No: 25-082

Municipality	Jackson Township	Surveyor	Not provided	Engineer	Robert Ruth		
Plat Title	Joel Weaver Ag Operation						
	Not applicable		Proposed Land Use	Agricultural (AG) and Single-family Residential (SF)			
	Preliminary	Plat Type:	Subdivision	Regulations:	X County		
	Final	X	Land Development		Municipal		
	X P/F		Combined		Zoning		
	Minor				S&LD		
# of New Lots	0	# of New Dwelling Units	0	Acreage Subdivided/ Developed	9.20	Total Acreage	96.17
Date Received	11/13/2025	Staff Review	12/02/2025	Official County Review		12/17/2025

JOEL WEAVER AG OPERATION

SHEET 3 OF 17

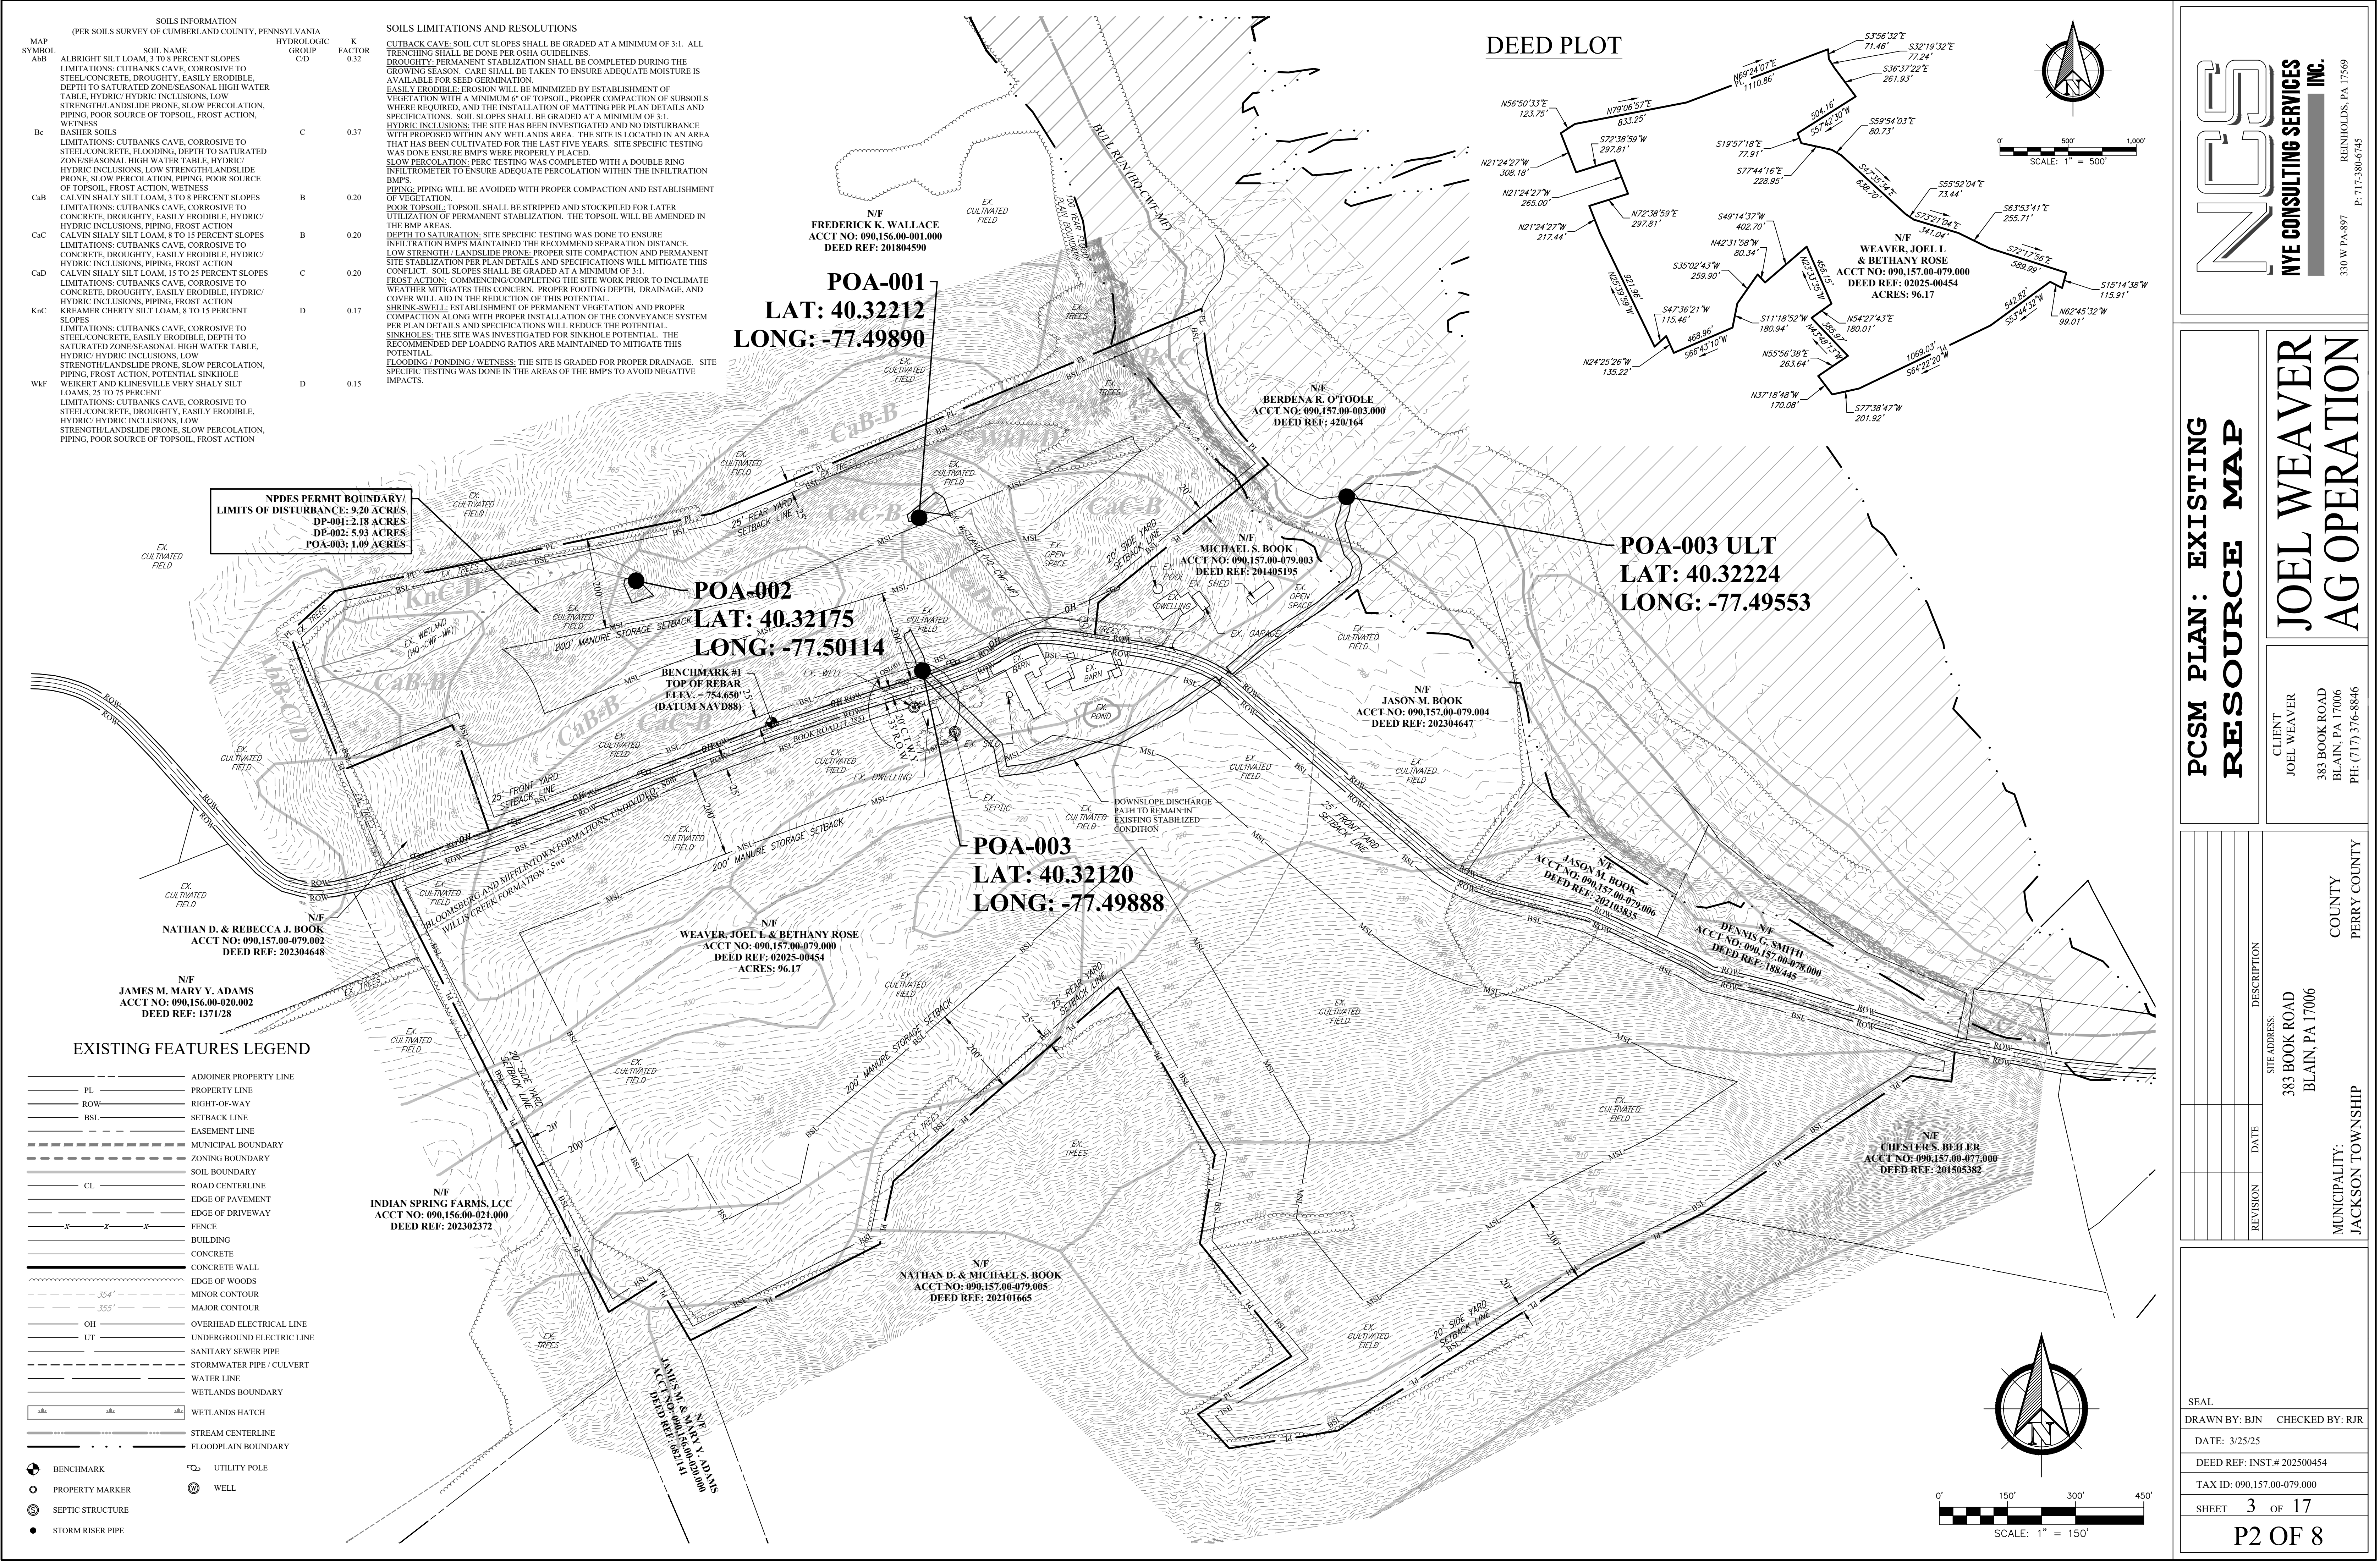
- Sheet 3 of the plan mentions Frederick K. Wallace as the titleholder of the property proposed to be developed. The applicant’s agent will need to provide documentation to our office file to validate the landowner’s signature(s) as current.
